DEVELOPMENT APPLICATION ASSESSMENT REPORT

Application Number:	DA2021/0668
----------------------------	-------------

Responsible Officer:	Rebecca Englund
Land to be developed (Address):	Lot 81 DP 8076, 95 Bower Street MANLY NSW 2095
Proposed Development:	Alterations and additions to a dwelling house
Zoning:	Manly LEP2013 - Land zoned R1 General Residential
Development Permissible:	Yes
Existing Use Rights:	No
Consent Authority:	Northern Beaches Council
Delegation Level:	DDP
Land and Environment Court Action:	No
Owner:	Trustees Roman Catholic Church Archdiocese Sydney Ikuyo Feldman
Applicant:	Your Beautiful Home Pty Ltd

Image 1 - View from primary rear balcony of 29 Reddall Street in seated position.

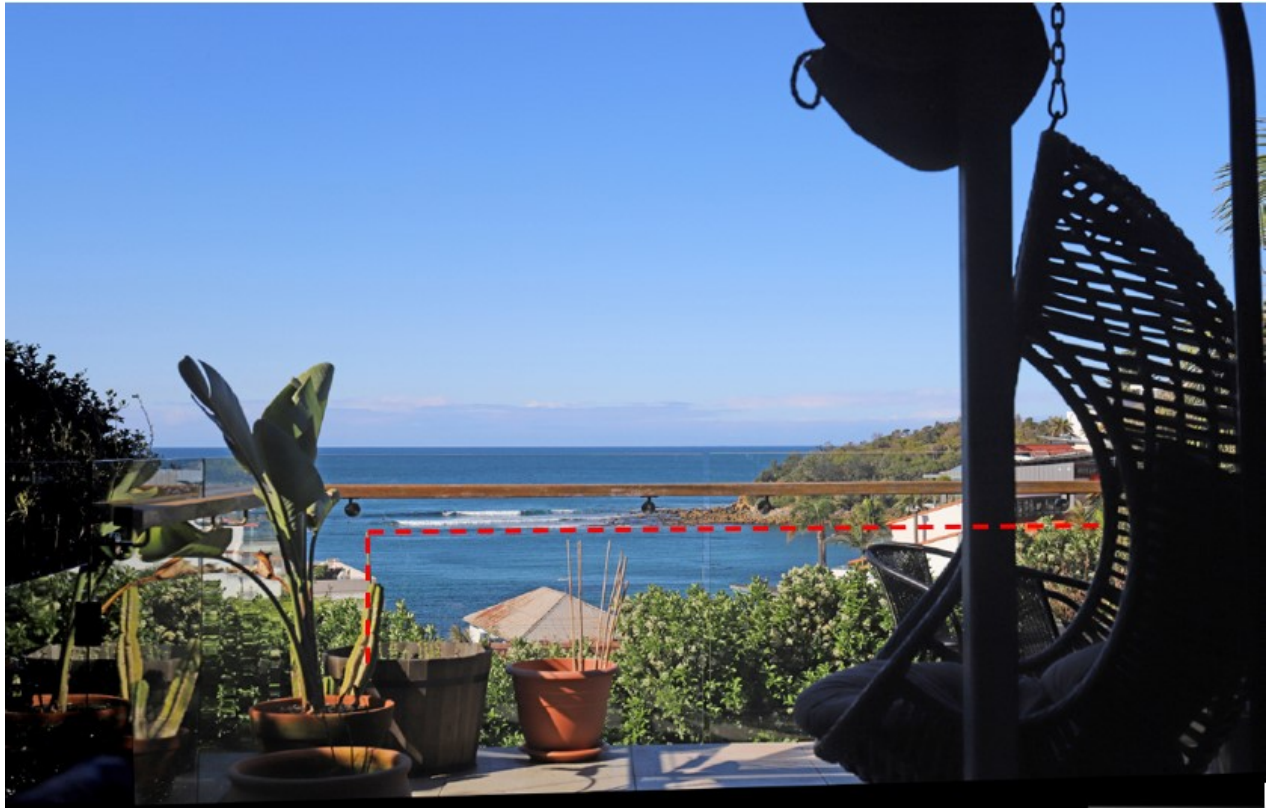
It is the view corridor from a seated position in the primary area of the balcony that is most affected by the proposal, as depicted in Image 1, below. The originally proposed roof would have resulted in the obstruction of the majority of the foreground water currently enjoyed. The impact upon this view was considered to be moderate.

Based on the amended plans, the cumulative impact upon views currently enjoyed from 29 Reddall Street is considered minor.

4. The amended plans, which minimise the pitch of the roof and increase the setback of the upper floor from the north-western side boundary, are considered to represent a skilful design solution that ensures view sharing between properties is achieved. The impact upon the views currently enjoyed from 29 Reddall Street is reasonable.
